## UNITED STATES OF AMERICA BEFORE THE FEDERAL ENERGY REGULATORY COMMISSION

)	Project No. P-2082-062
)	
)	
)	
)	Project No. P-14803-000
	) ) ) )

### PACIFICORP'S RESPONSES TO ADDITIONAL INFORMATION REQUEST QUESTION NOS. 7, 8, 9 AND 11

# P-2082-\_\_\_, Attachment H - K-3 - Project Boundary Description (09.23.16)

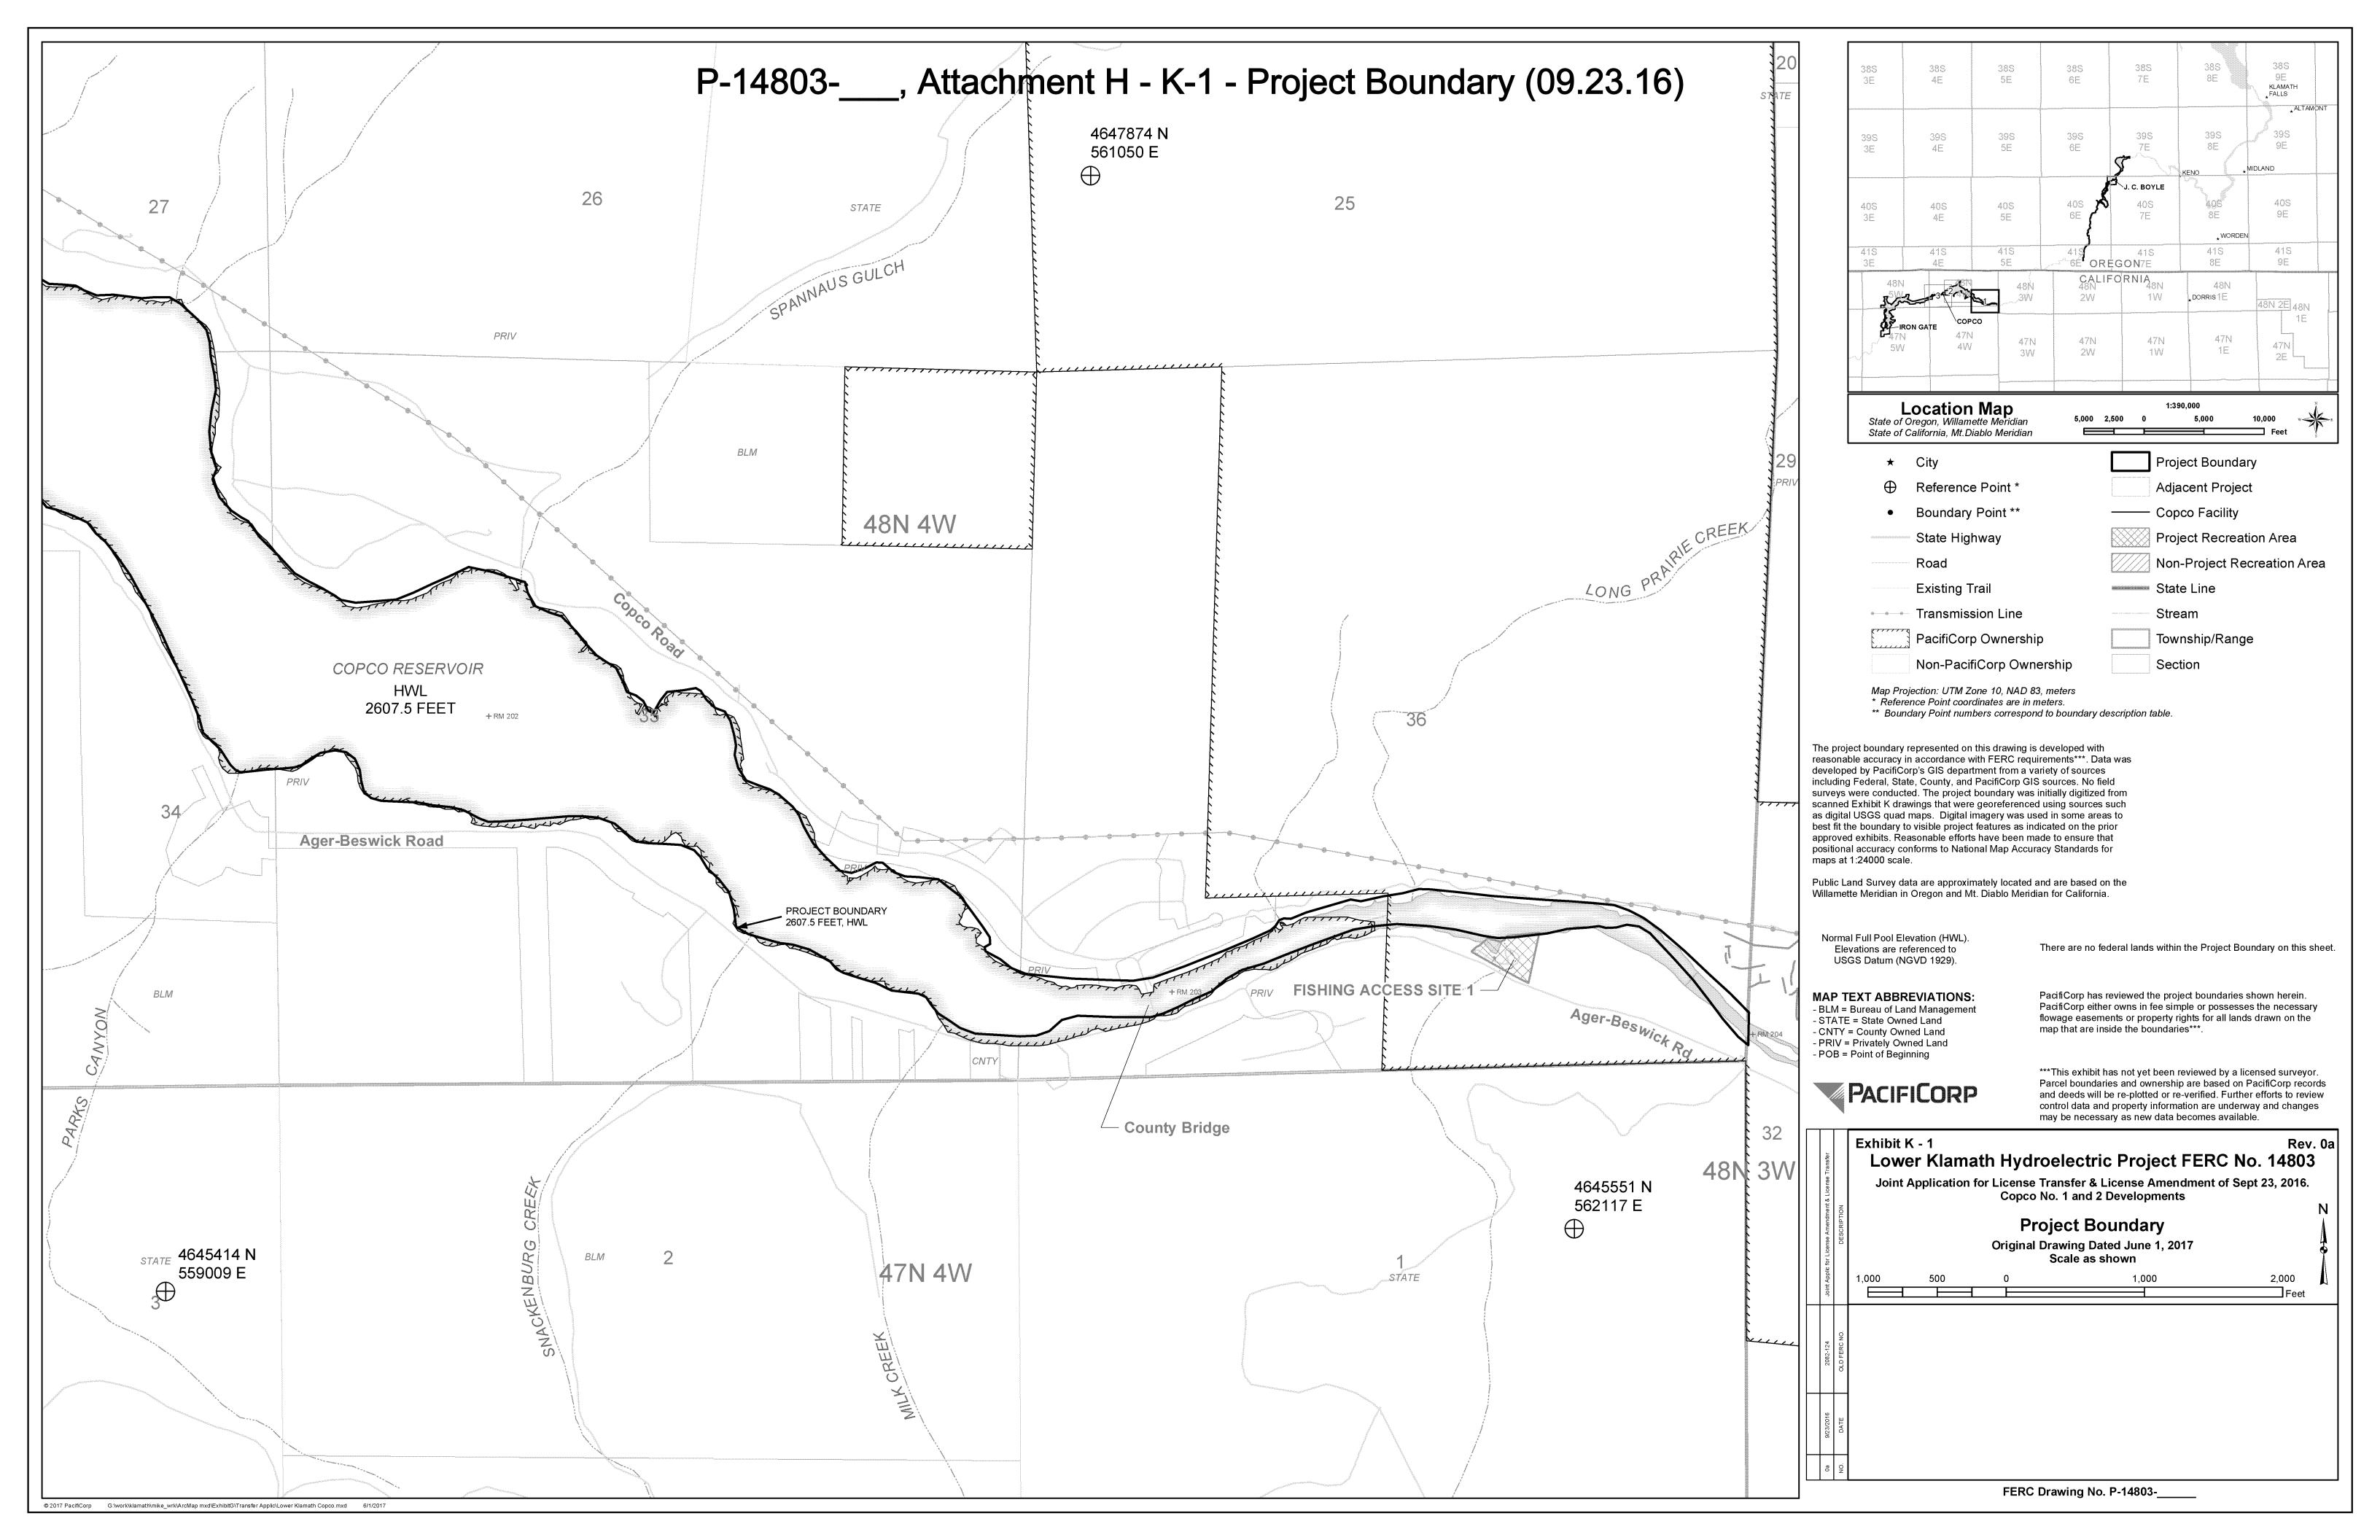
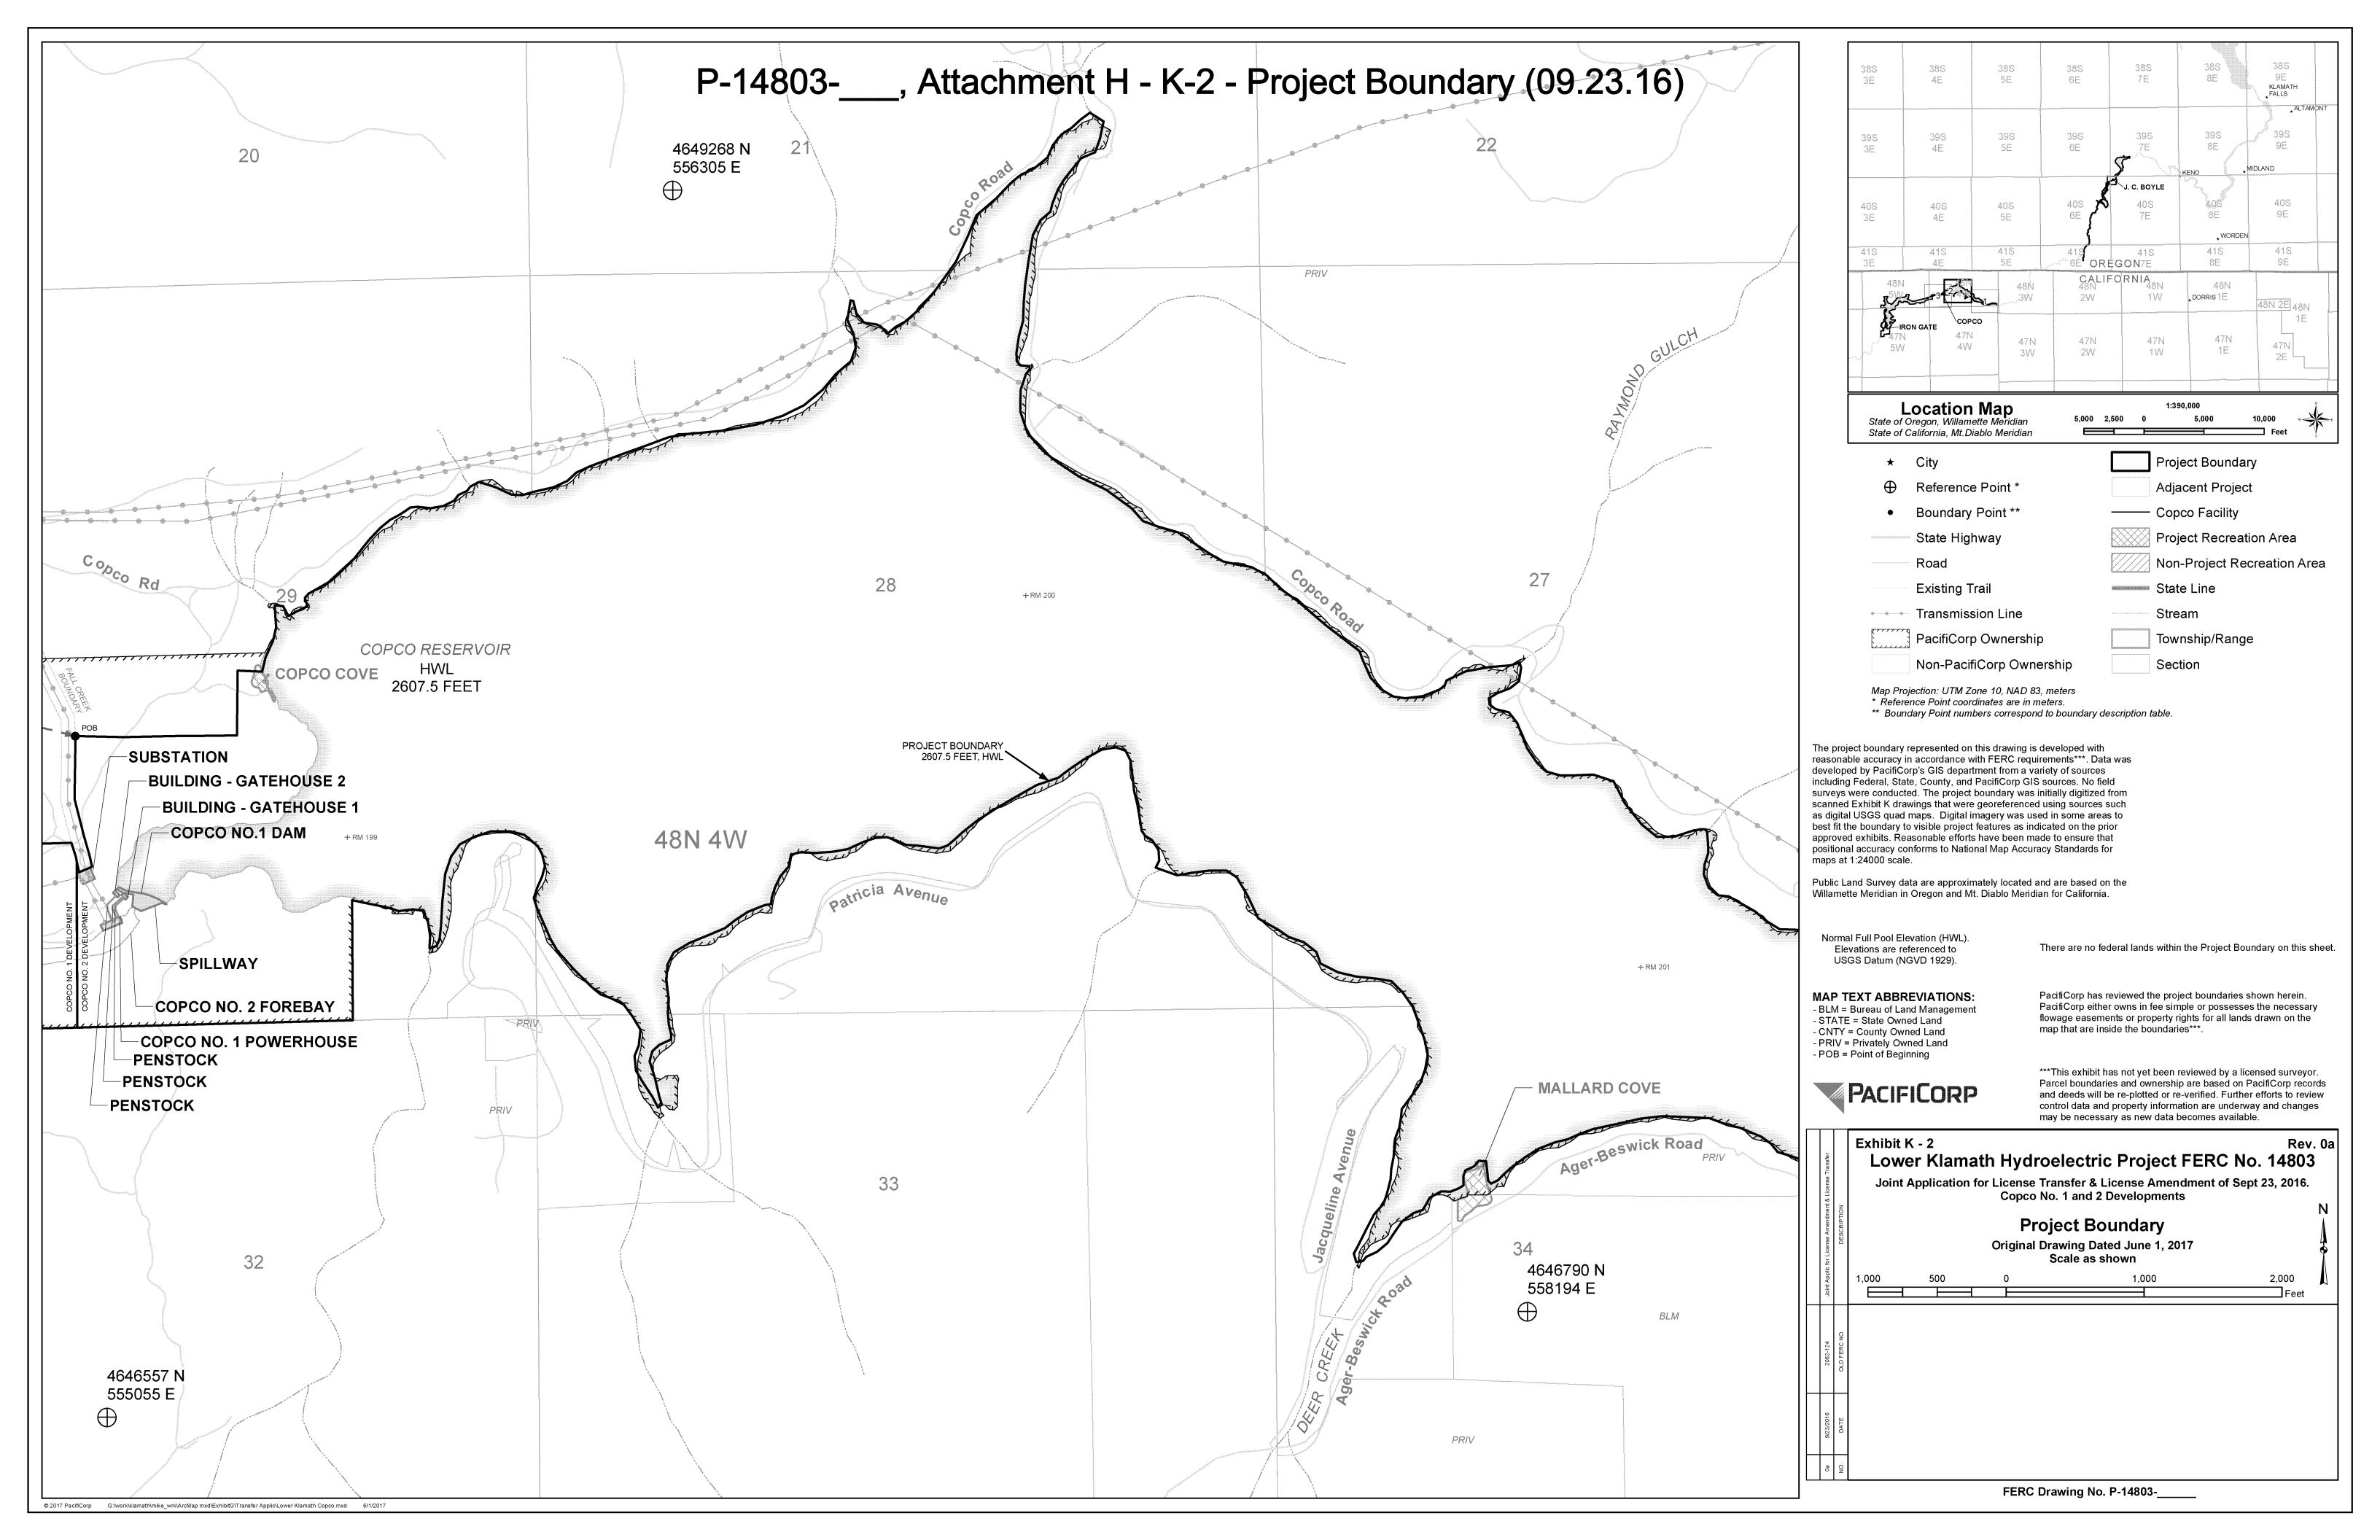
Pursuant to the Commission's regulations at 18 CFR, section 4.201 (c), the amendment application must contain those exhibits that require revision in light of the nature of the proposed amendment. Therefore, the licensee must include with the amendment application revised exhibits F and G to reflect the proposed changes. Please refer to the attached list of current exhibit drawings under the license, and provide revised exhibits accordingly. Any exhibit drawings must be prepared in accordance with 18 CFR sections 4.39 and 4.41 (g) and (h).

Attached to this AIR response as Attachment H are provisional project boundary drawings that provide additional detail on the proposed boundary changes. To date, PacifiCorp has determined that three drawings require revisions in light of the proposed amendment. These are drawings 2082-124, 2082-125, and 2082-228, which represent the separation of the Copco and Fall Creek developments. PacifiCorp has prepared these provisional drawings to more clearly define the boundaries for the Klamath Hydroelectric Project and the new Lower Klamath

This revised project boundary exhibit was prepared for the application for amendment and partial transfer of the license for the Klamath Hydroelectric Project (FERC No. 2082). It supersedes the current exhibit sheets for the area where the Klamath Hydroelectric Project and the proposed Lower Klamath Project (FERC No. 14803) adjoin. The project boundary on this exhibit represents the same project boundary as shown on the approved Exhibit K sheets for the Fall Creek, Copco No. 1, and Copco No. 2 developments of the existing Klamath Hydroelectric Project, and adds the separate project boundaries where the Fall Creek transmission line corridor connects to the substation northwest of the Copco No. 1 powerhouse.
